**Re: Ecology Contingent Approval Letter for the Draft Indoor Air Sampling and Analysis Plan (SAP) for the McKinstry Building located at 5005 3<sup>rd</sup> Ave. South, Seattle, Washington, dated December 18, 2018**

Attachment A: Ecology Comments, Clarifications, and Required Modifications for the  
Contingently Approved Indoor Air Sampling and Analysis Plan (SAP)

**Attachment A:** Ecology Comments, Clarifications, and Required Modifications for the Contingently Approved Indoor Air Sampling and Analysis Plan (SAP) for the McKinstry Building Located at 5005 3<sup>rd</sup> Avenue South, Seattle, Washington, dated December 18, 2018

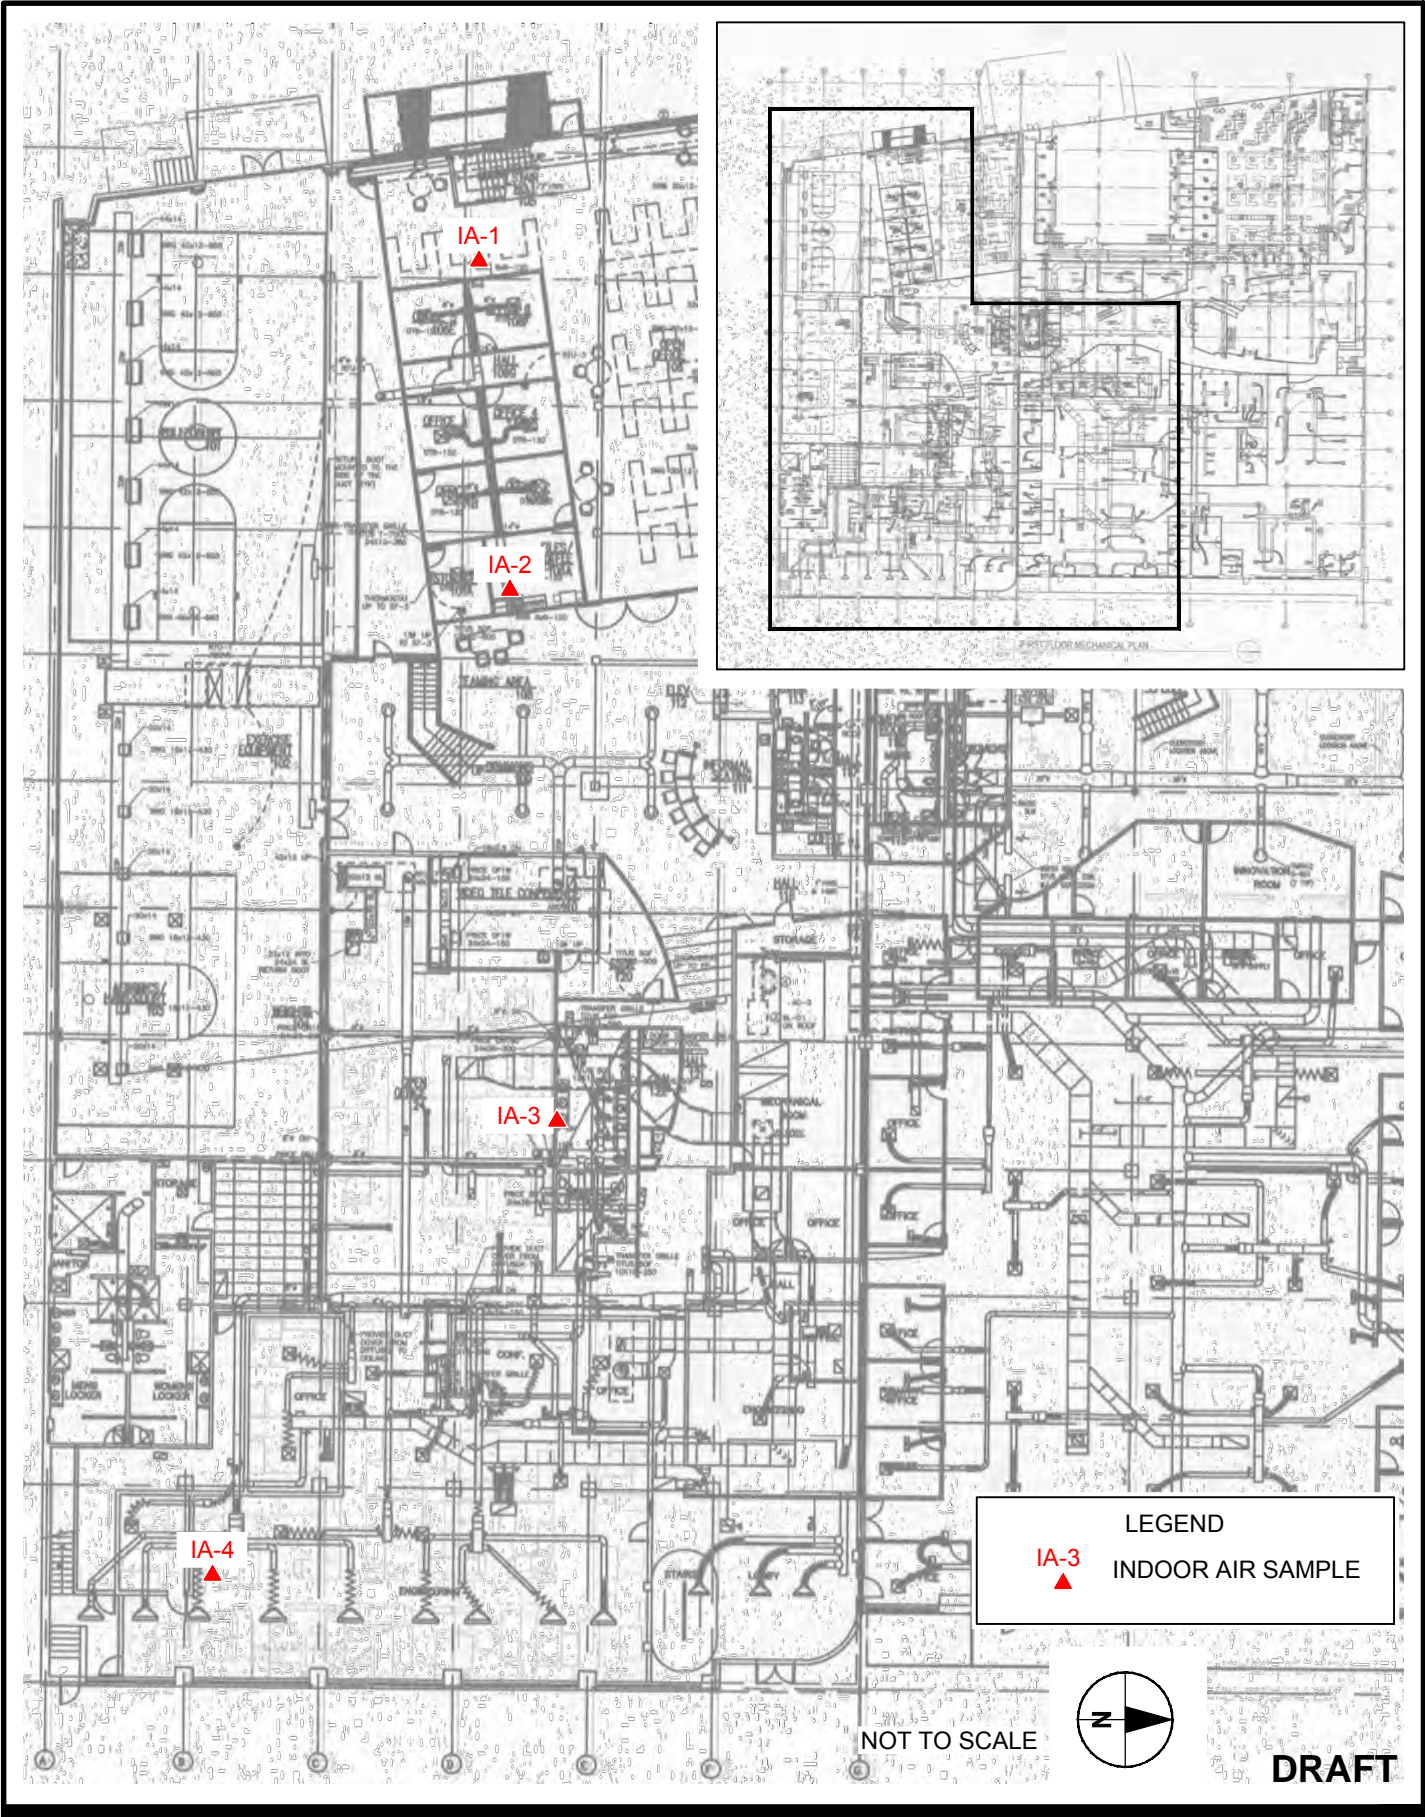
3. Figure 2: Revise and resubmit Figure 2 that includes a short description of the four areas within the McKinstry building where indoor air sampling is planned. For example, the short description should include, at a minimum, if the sample location is an open space or enclosed office with its own door; ceiling height; location of any HVAC vents, etc. Ecology has requested that GE/AECOM also indicate if women are present in those indoor air sampling locations (Figure 2). Resubmit the revised Figure 2 within 14 calendar days of GE's receipt of this letter.

5. Section 2.3 Air Sampling Methods and Procedures: GE shall include at least one field duplicate sample in one of the enclosed offices (Figure 2).
6. Section 2.3 Air Sampling Methods and Procedures: GE shall record the wind direction before and during indoor (and ambient) air sampling.
